PLANNING & ZONING COMMISSION REGULAR MEETING AGENDA

Turf Grass - Rifle Municipal Code Proposed Text Amendment

1. Turf Grass - Proposed Municipal Code Amendment for Discussion - Workshop 12_09_2025

Typical components of a landscape treatment area.

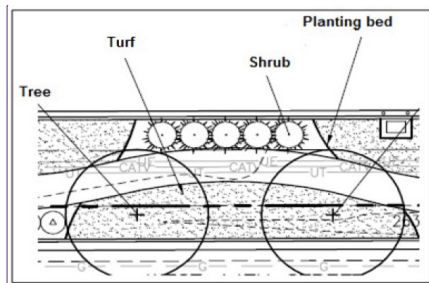
Commented [LB31]: Consider a new graphic as this looks like a thin strip of nonfunctional turf. Alternatively change "Turf" to read "Native or climate adapted grass".
